INTERSTATE ROUTE H-2 HOV LANES, PHASE I
WAIPIO TO WAIAWA INTERCHANGE
Project No. IR-H2-1(26)

STATE OF HAWAII DEPARTMENT OF TRANSPORTATION HIGHWAYS DIVISION	
RETAINING WALL PLAN AND ELEVATION	
I.B. STA. 375+00 TO STA. 376+97	
I.B. STA. 403+75 TO STA. 406+00	
INTERSTATE ROUTE H-2, HOV LANES, PHASE I	
WAIPIO INTERCHANGE TO WAIPILO INTERCHANGE	
Project No. IR-H2-11(26)	
Scale: As Noted	Date: Jan. 1991
SHEET No. S2 OF 20 SHEETS

"AS-BUILT"

SHEET No. S9 OF 20 SHEETS

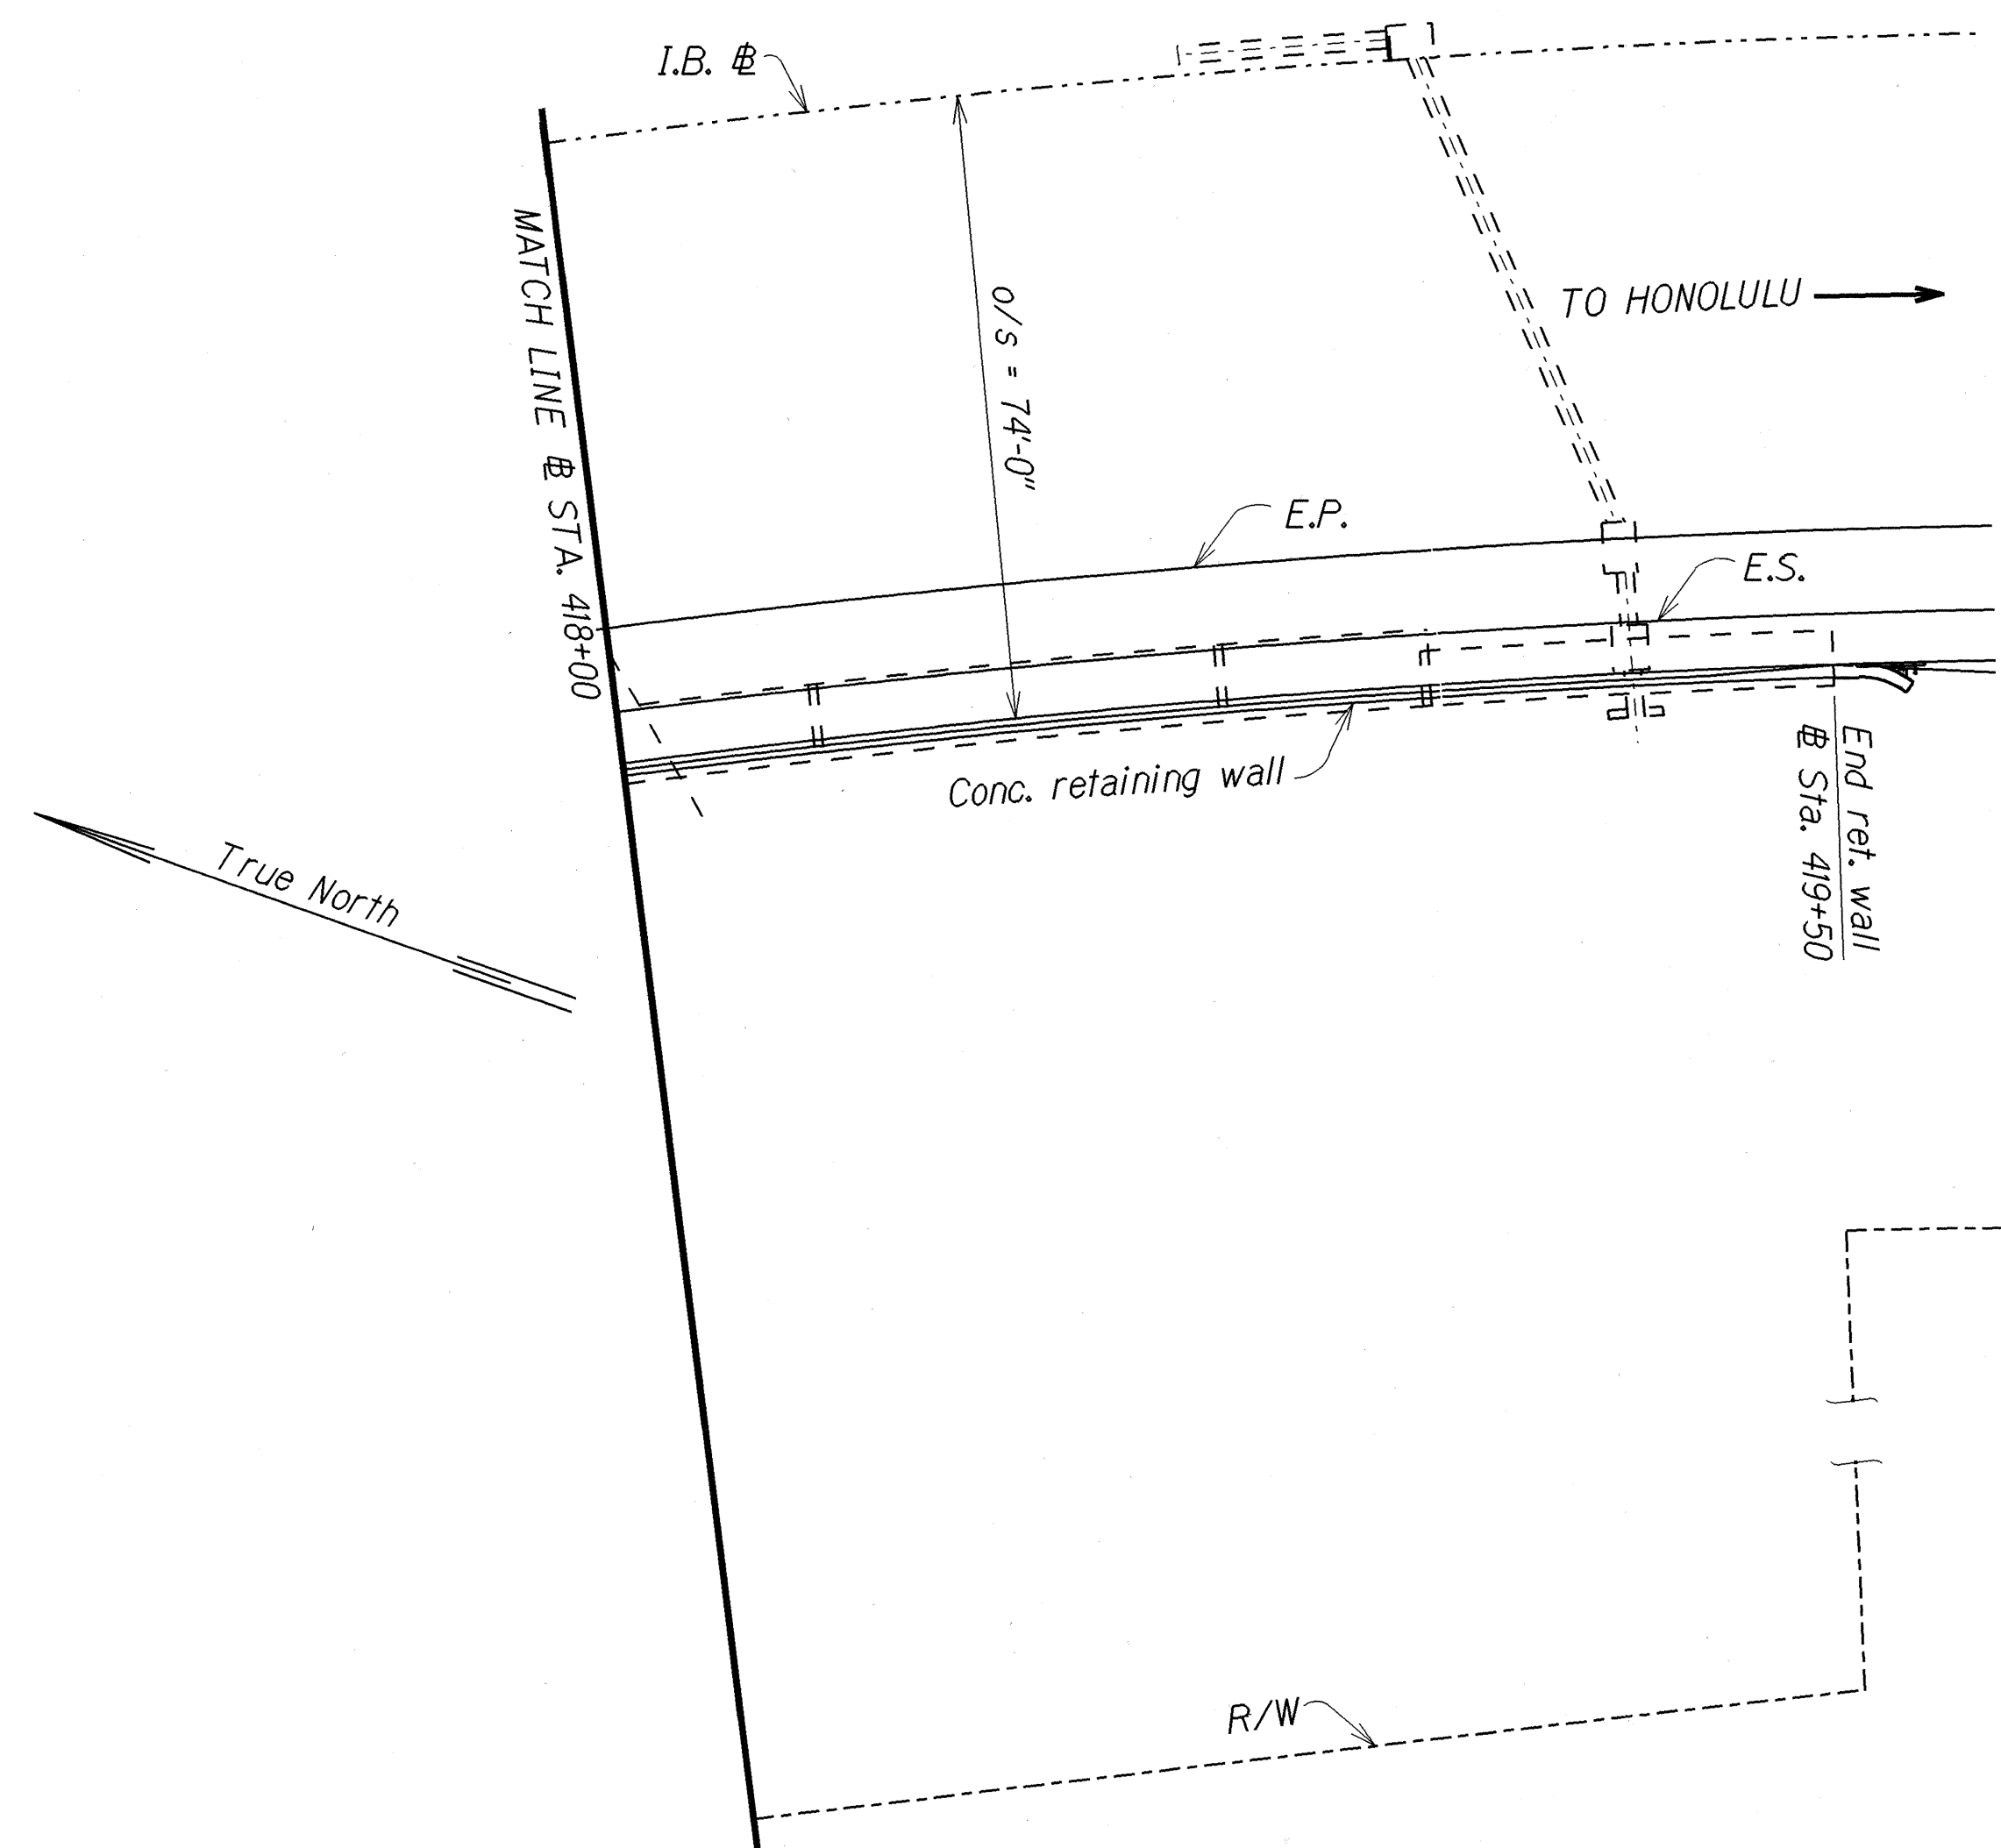
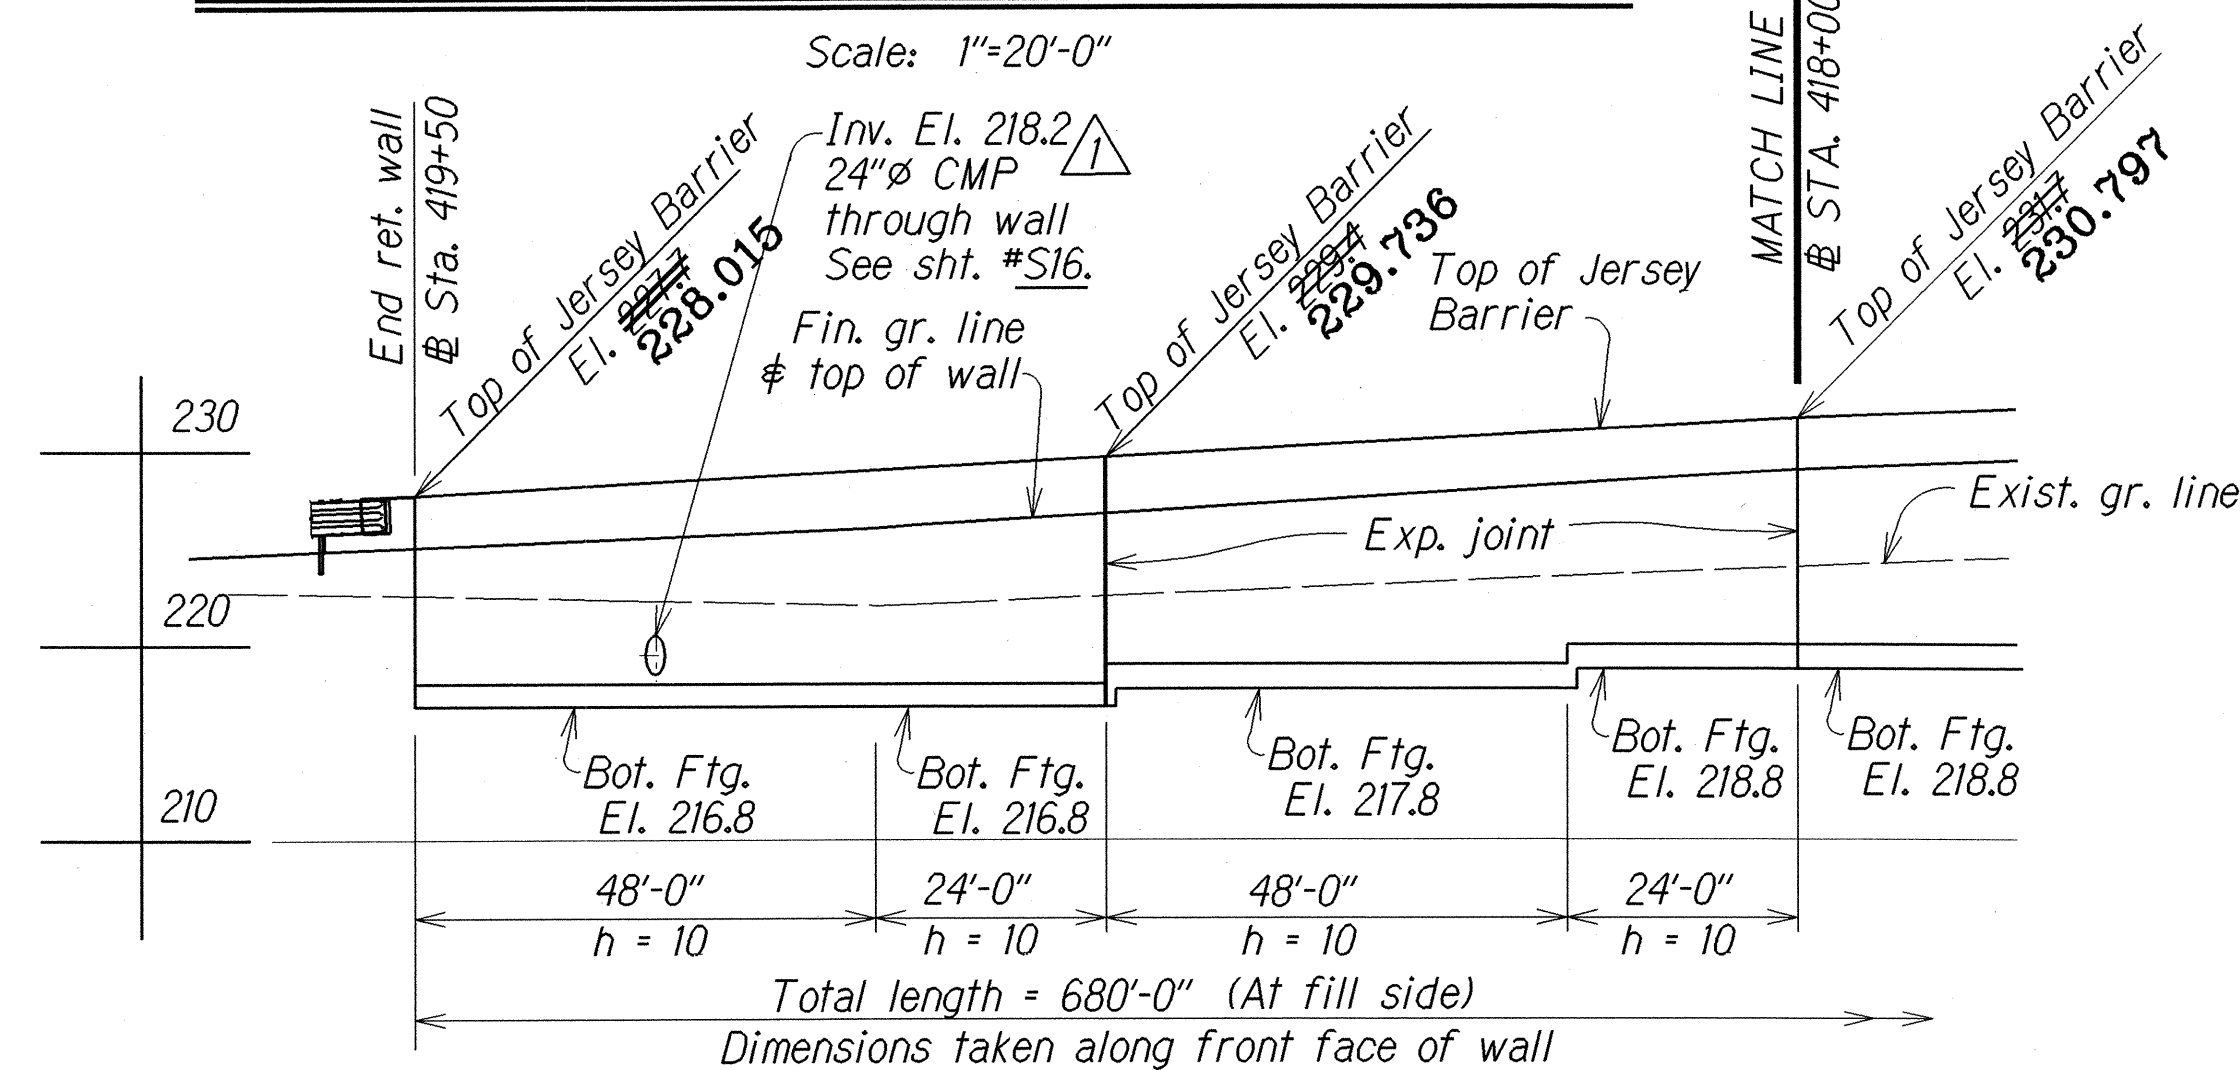
Corrected invert elevation & location of CMP at I.B. Sta. 419+25.0

REINFORCING AT 24"Ø CMP
INBOUND @ STA. 419+25.0±

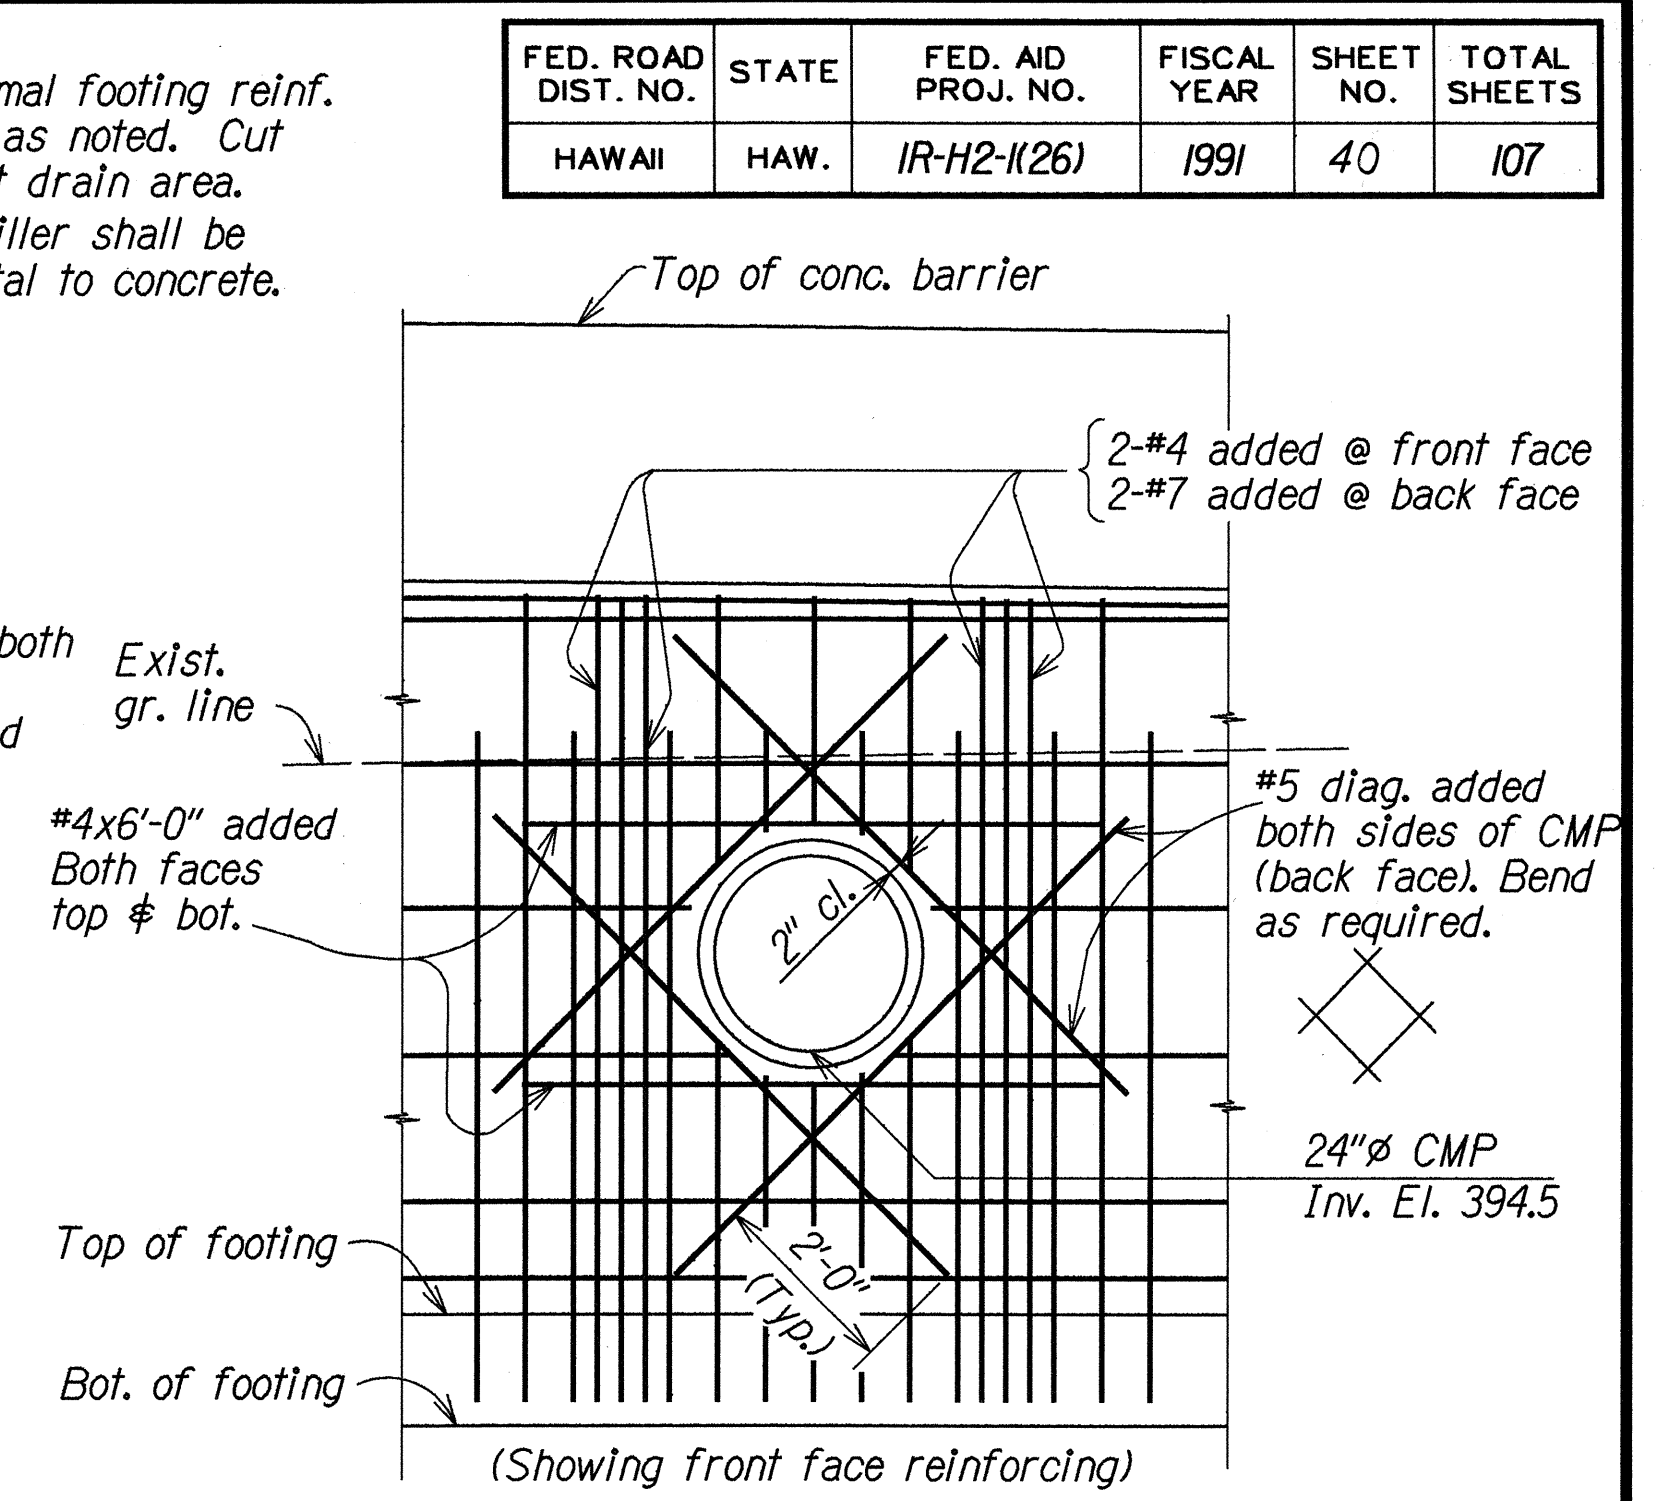
DATE	REVISION
11/14/91	Corrected INBOUND to OUTBOUND. Changed "h" to top ret. wall.
6/24/91	Corrected invert elevation & location of CMP at I.B. @ Sta. 419+25.0 & removed arrows from horizontal reinf. at 36"Ø CMP. Removed h=6' Vertical Reinf. Steel Arrangement At Cut Side.
